Service Bulletin

RRP Service Bulletin No: RRP SB355

Title: Advance Tie Plate Inserter Guide Roller Plate

Product Series: Advance Tie Plate Inserter [ATPI]

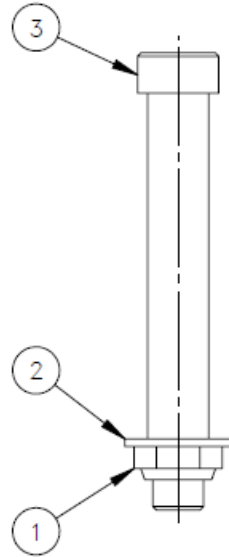
Drill out the counter-bore hole to a thru-hole on Guide Roller Plate (p/n 397933). See Instructions on page 3.

Kit, Workhead Guide Roller Shoulder Bolt / RRP# 793100 [Rev 1 (12.2020)]

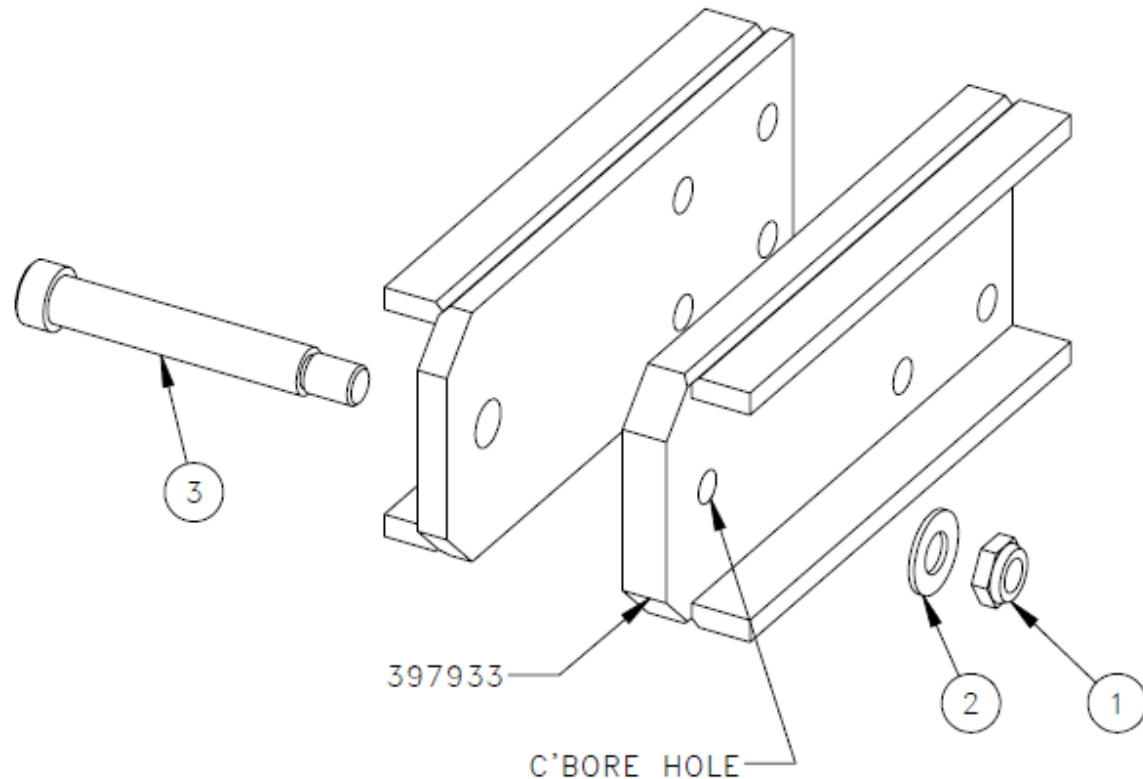
Workhead Guide Roller shoulder bolt to be replaced with a longer bolt and flat washer to better hold against the shoulder.

1. Drill out $\varnothing.752$ existing C'Bore hole on Guide Roller Plate 397933 to make thru-hole.
2. Replace (4x) 491207 shoulder bolts with (4x) 491640.
3. Add (4x) 491415 flat washers and (4x) 467679 nuts.
